CLEARFIELD CREEK WATERSHED TMDL Clearfield and Cambria Counties

Pennsylvania Department of Environmental Protection

January 19, 2007

Comment and Response

Figure 1. Impaired Waters in the Clearfield Creek Watershed

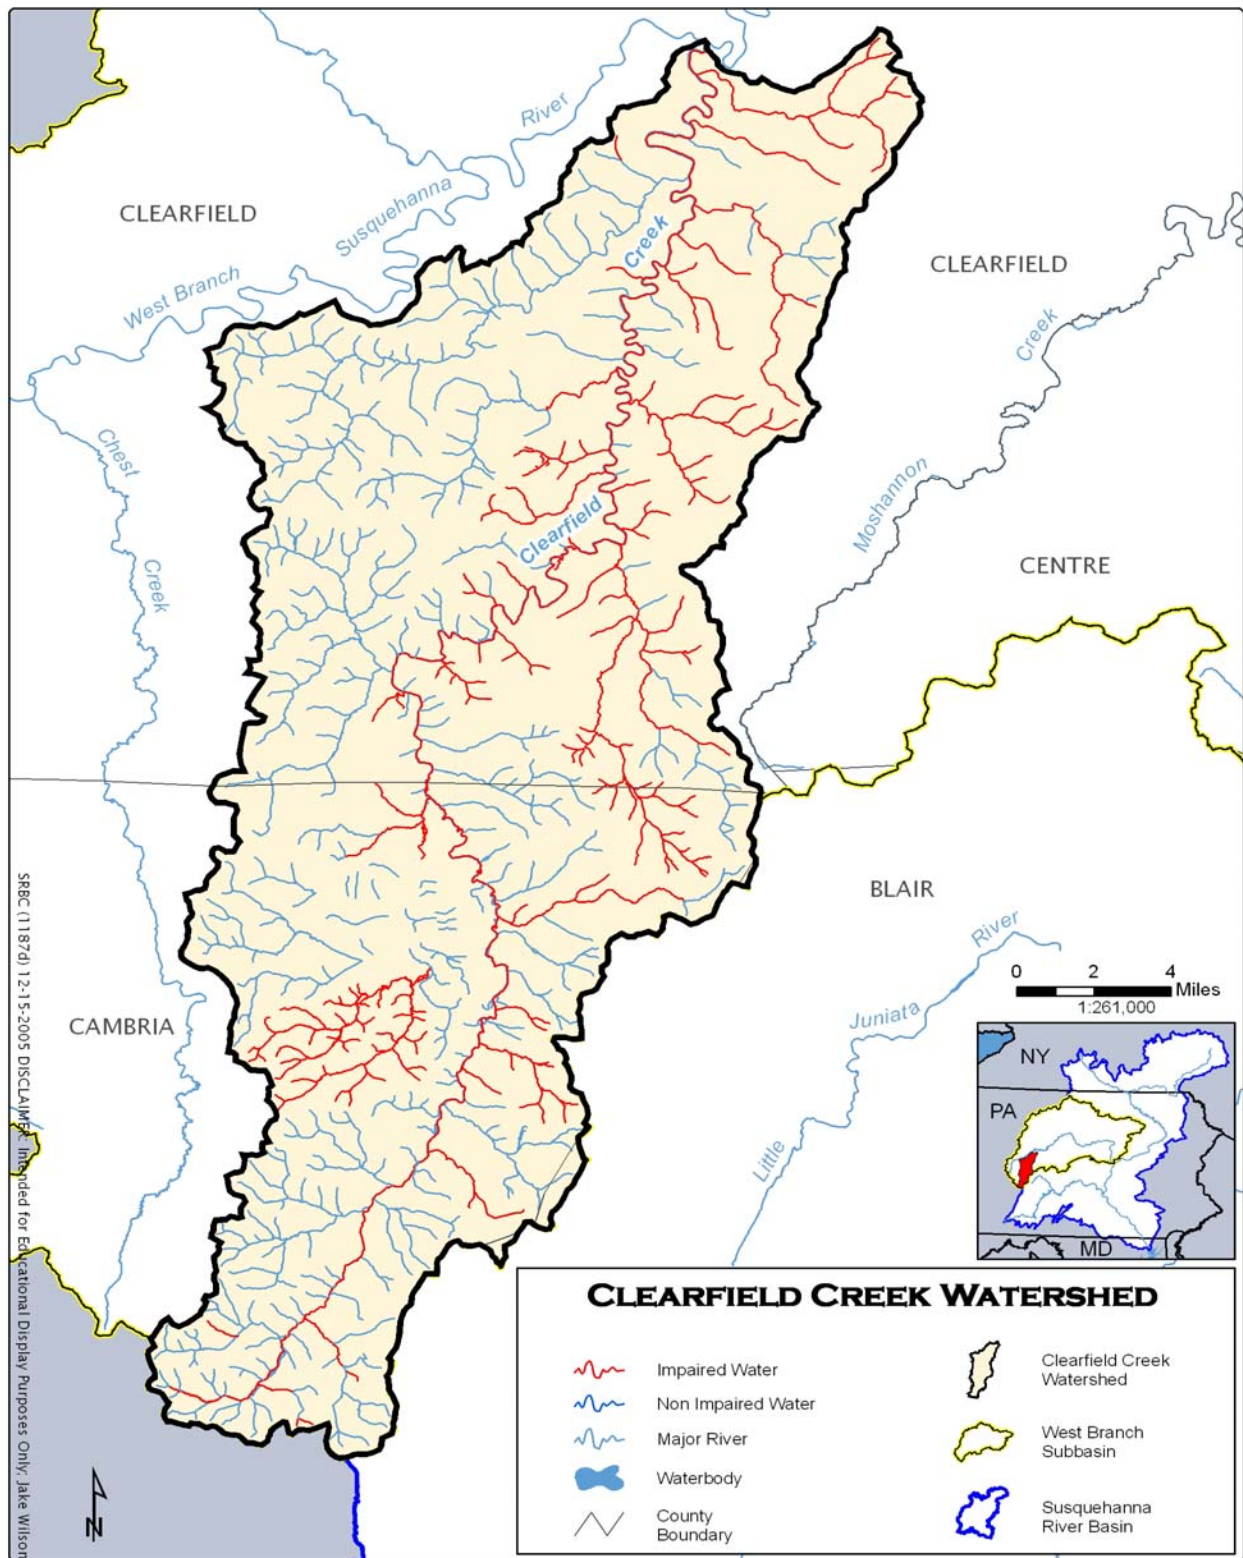
Figure 1, showing impaired waters. Blain Run near Coalport is badly degraded by AMD for about a mile. Also, a major Fe-rich discharge enters Turner Run about ½ mile above junction with Clearfield Creek. Bradley Run near Gallitzin is degraded. These sites are identified in the Clearfield Creek Assessment Report. This report is not mentioned in the previous section on past studies, though it is mentioned later. Also, the Scarlift reports on Clearfield Creek and Muddy Run are not mentioned.

According to the PADEP 2006 Integrated List of impaired waters, Blain Run, and Turner Run are not listed as being impaired. Bradley Run was added to the list of larger AMD tributaries to Clearfield Creek in the *Segments Addressed in this TMDL* section.

CLEARFIELD CREEK WATERSHED - NORTHERN SECTION

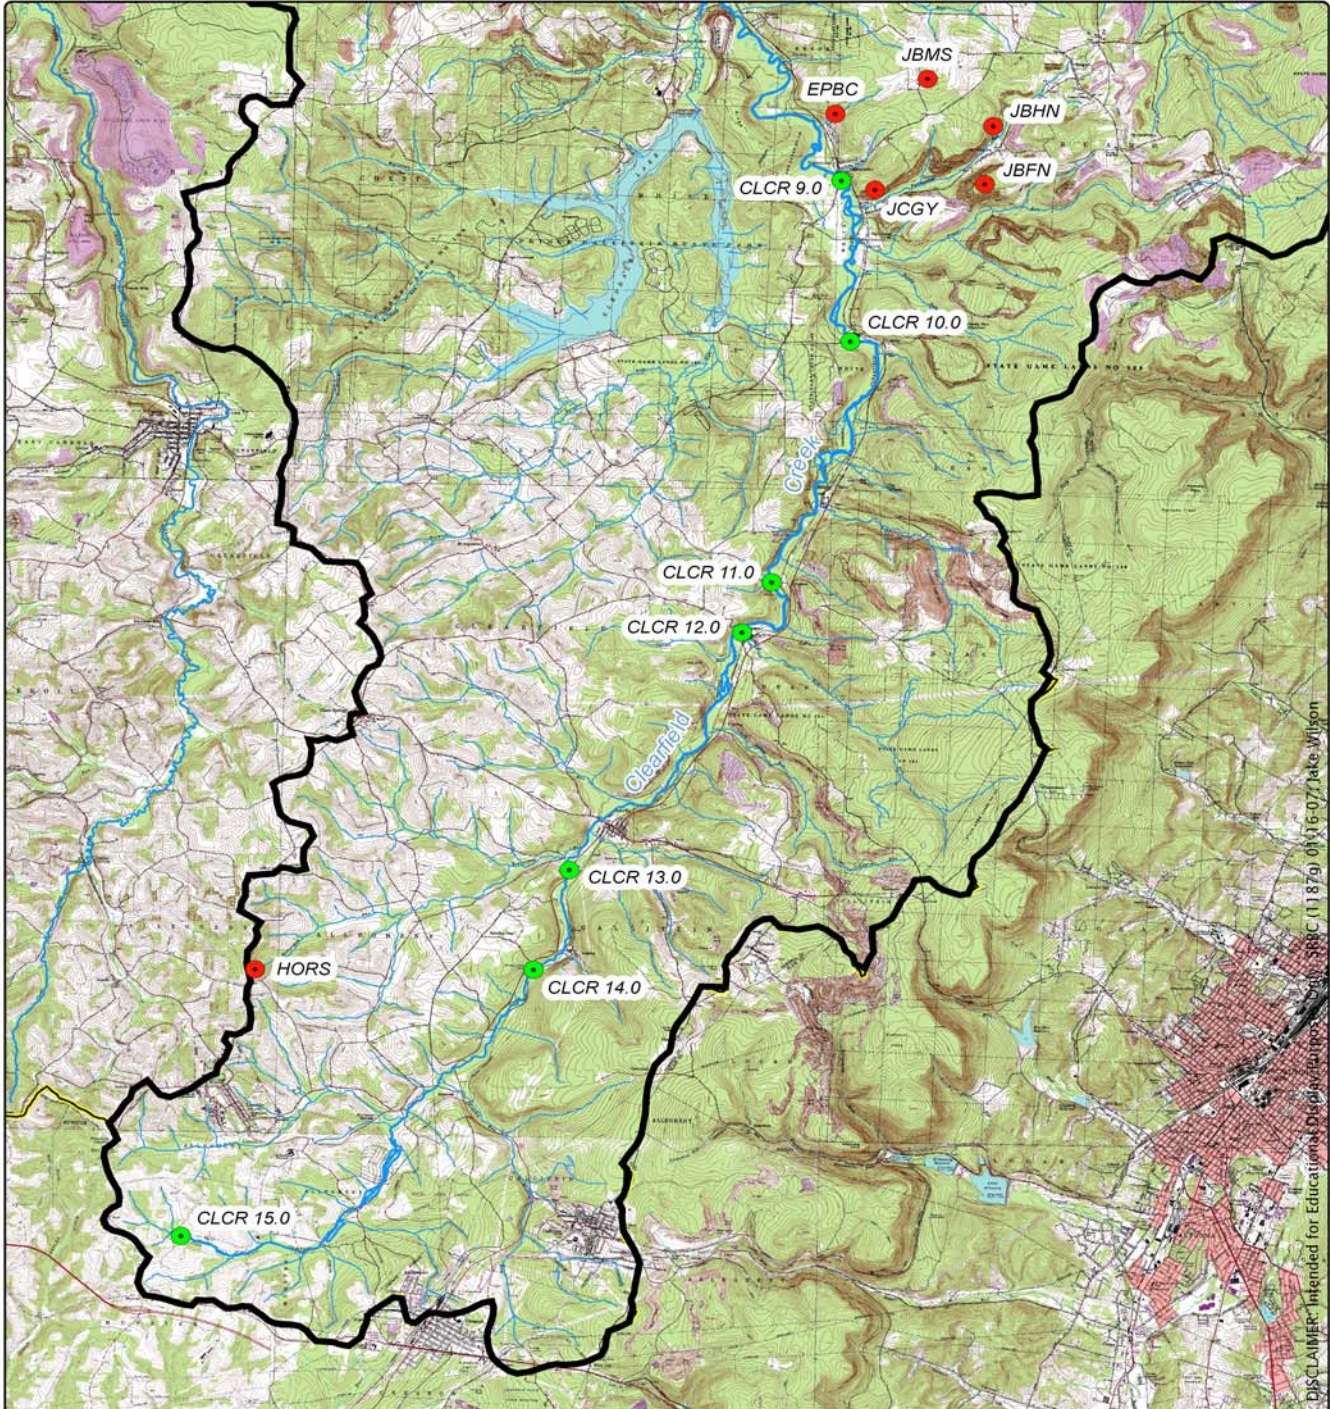
Map 1. The Cooney permit (11850102) near Buckhorn is not shown on the map, but has a Subchapter F point that is a significant source of acid. See my Restoration Plan for Little Laurel Run.
